September 27, 1972

WATTS BAR NUCLEAR PLANT - FINAL ENVIRONMENTAL STATEMENT

ERRATA

FIGURE 2.7-6

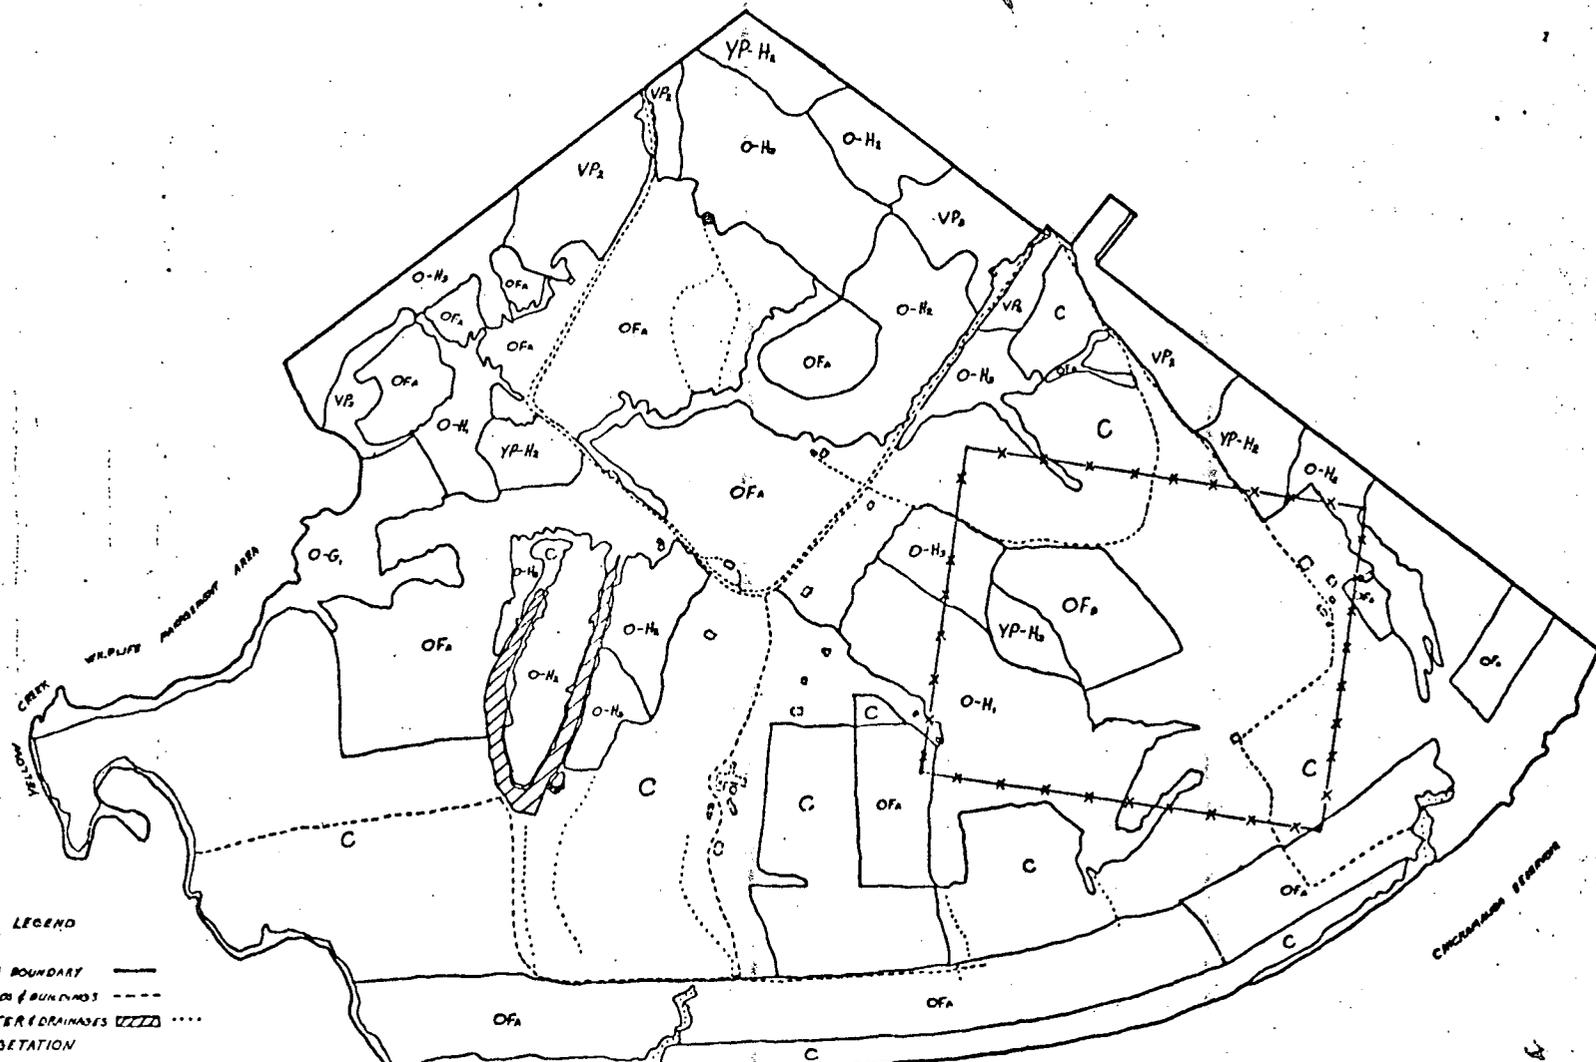
22. Page 2.7-24. Add new page, Figure 2.7-6 (attached).
